Property address: 1787 Normandy Drive Board DRB Date: 09/03/2020

Re: Response to Design Review Board Comments, **Plan # DRB20-0587**

RESPONSE TO DRB COMMENTS

DRB PLAN REVIEW	
09/30/2020 Review by Sotelo, Fernanda	
Staff First Submittal Comments Design Review Board SUBJECT: DRB20-0587, 1787 Normandy Drive Review Comments: 09/30/20 Final CAP/Formal Submittal: 12:00 PM on 10/12/20 Notice to Proceed: 10/19/20 Tentative Board Meeting Date: 12/07/20	
<p>For the health and safety of our customers and staff, and in an effort to continue to provide service to our residents and development community, the Planning department will be transitioning the "CSS & Paper Submittal" step to an electronic "Formal Submittal". The timing of this upload is the same as the previous paper submittal, but applicants are just uploading two files to CSS titled "Formal Submittal" and "Formal Mail Notice". This takes the place of the paper submittal. The format must be consistent with the attached instructions, titled "Novus Formal Submittal Format Standards". Please keep in mind that the submittal MUST be consistent with the plans / document which allowed the application to receive a Notice to Proceed. As cus

SITE PLAN GROUND
LEVEL

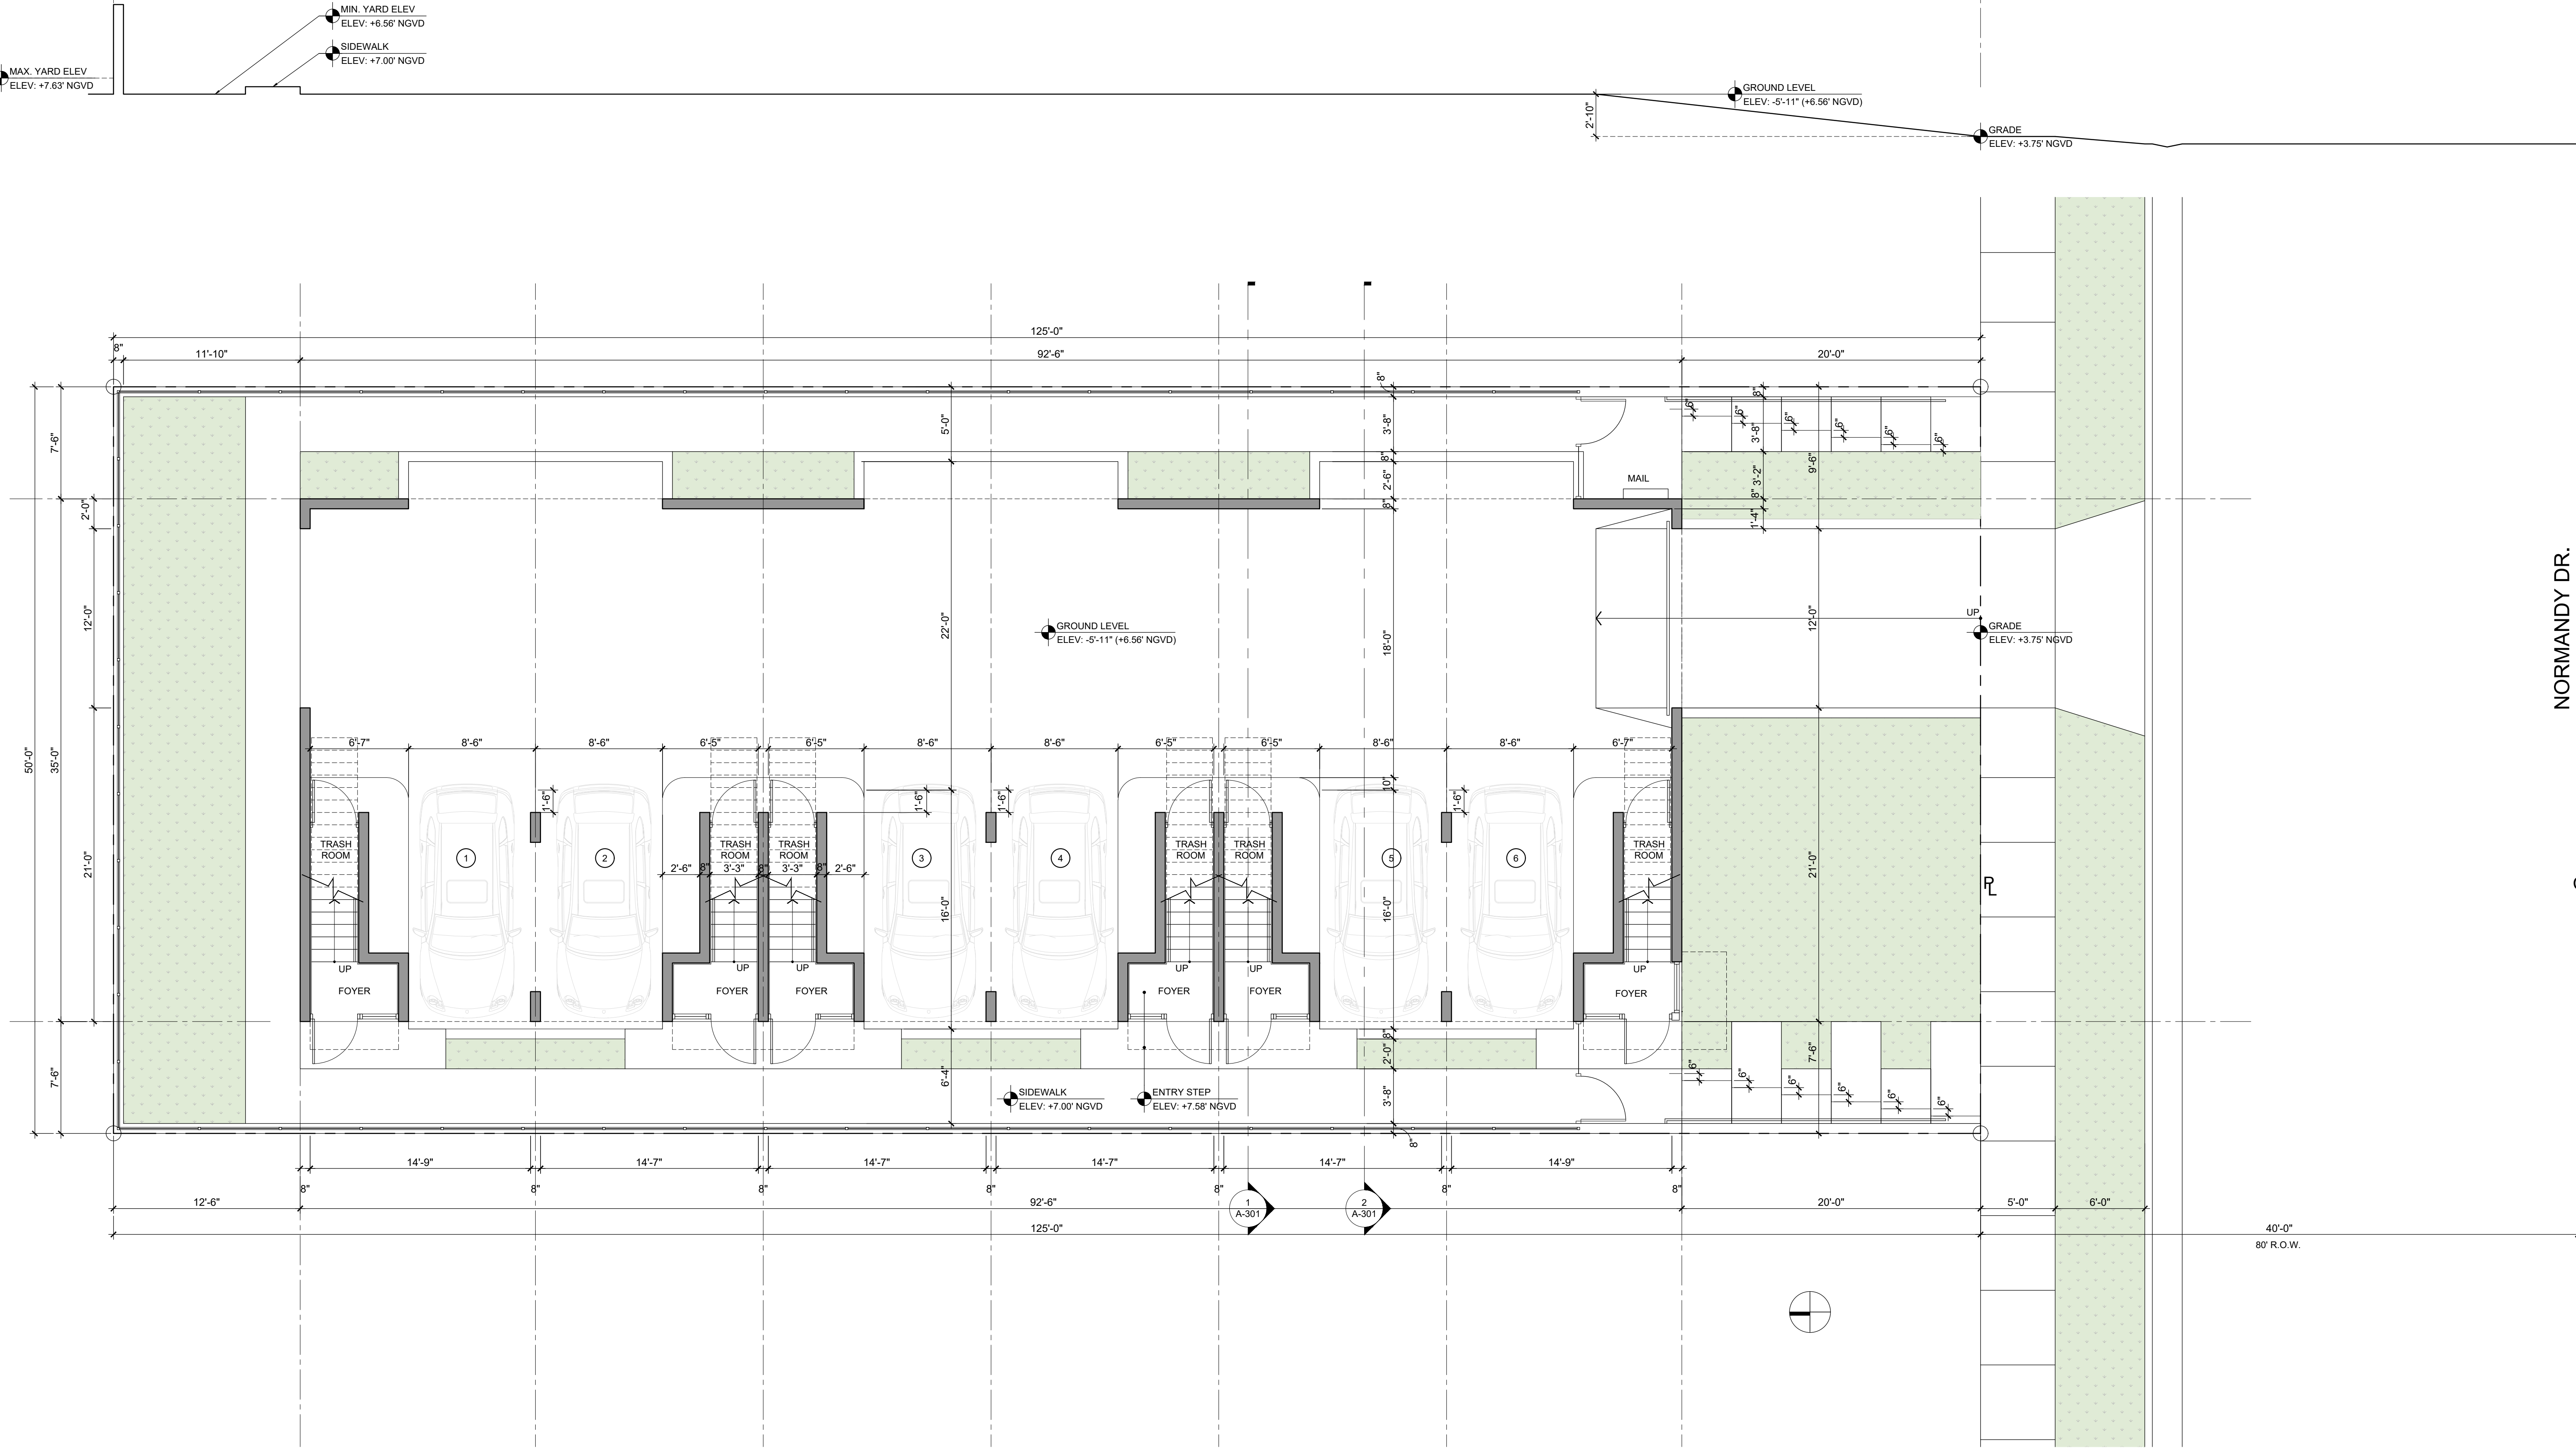
7. Staff would recommend eliminating one of the walkways on the sides and in the rear to increase the landscape and permeability of the site.	Landscape and permeability of the site was increased. Both walkways are going to be made of gravel and on the sides a landscape strip where Lily Turfs and Climbing Figs will be planted. Refer to the site plan A-100 and the Landscape plans.
